**GEOTECHNICAL PLAN REVIEW UPDATE
AND RESPONSE TO CITY OF SAN DIEGO CYCLE ISSUES
PROPOSED TWO-LOT RESIDENTIAL DEVELOPMENT
BEELER CANYON ROAD
SAN DIEGO, CALIFORNIA**

Project No. GI-20-06-121

**Geotechnical Plan Review Update And Response to City of San Diego Cycle Issues
Proposed Two-Lot Residential Development, Beeler Canyon Road, San Diego, California**

SECTION "AA"
SCALE 1" = 20'

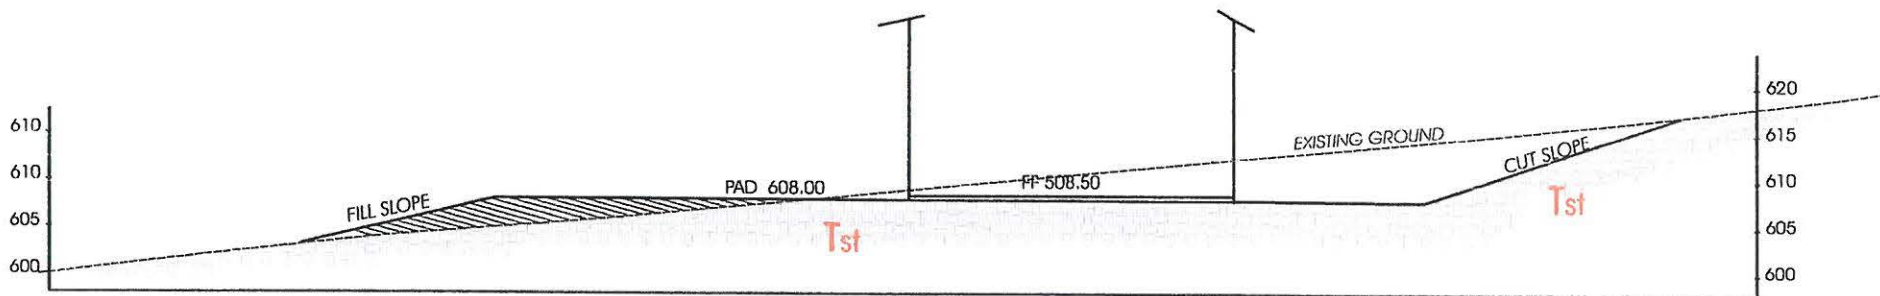
5. *Provide a geologic map and geologic cross section*
